CITY OF OLYMPIA
Olympia Design Review Board

DETAIL DESIGN REVIEW
STAFF REPORT
November 14, 2024

Project Name/Number:	The Cottage Apartments #24-1554
Applicant/ Representative:	Glenn Wells, Glen Wells Architects
Project Location:	414 & 422 Franz Anderson Road SE
Project Description:	Development of two multifamily buildings with a total of 58 residential units, 70 parking stalls, and associated site improvements.
Zoning District:	High Density Corridor 4 (HDC-4)
Design Districts:	High Density Corridor
Comprehensive Plan Designations:	Urban Corridor (UC)
Scenic Vista:	None
Critical Areas:	None
City Staff:	Lydia Moorehead, Associate Planner Phone: 360.570.3746 E-mail: lmoorehe@ci.olympia.wa.us
Public Notification:	In accordance with the Olympia Municipal Code (OMC) 18.78, public notification was mailed on May 23, 2023, to property owners and residents within 300 feet of the site, parties of record and recognized neighborhood associations.

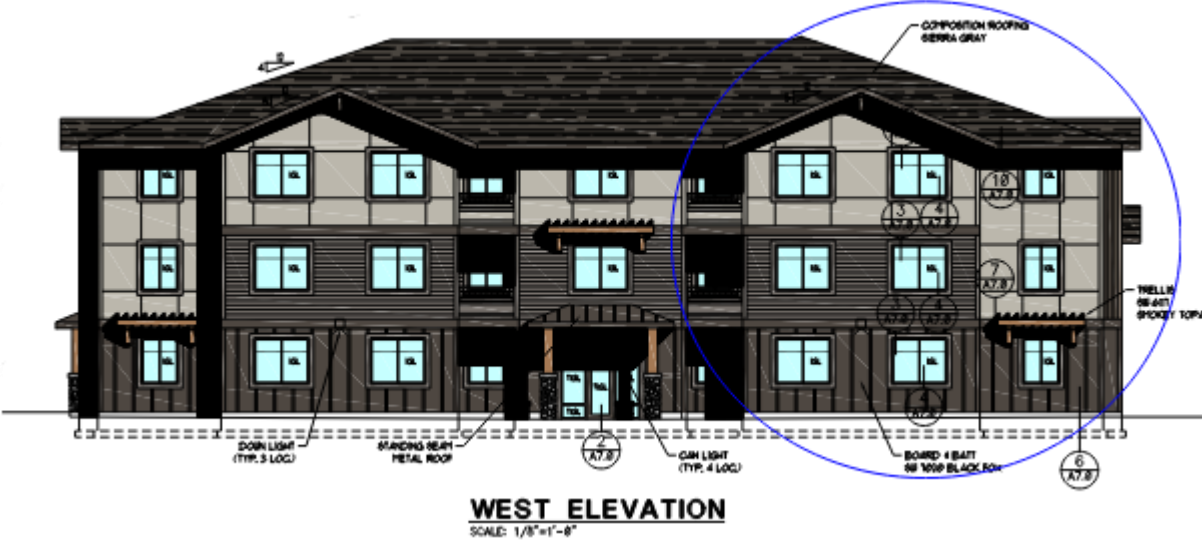
The first condition of the DRB’s concept review related to pedestrian circulation and landscaping. This condition has been satisfied with changes made to the site plan. The applicant has provided a pedestrian pathway that connects the north building to the solid waste facility and 10 feet of parking lot landscape screening is provided along the east property line.
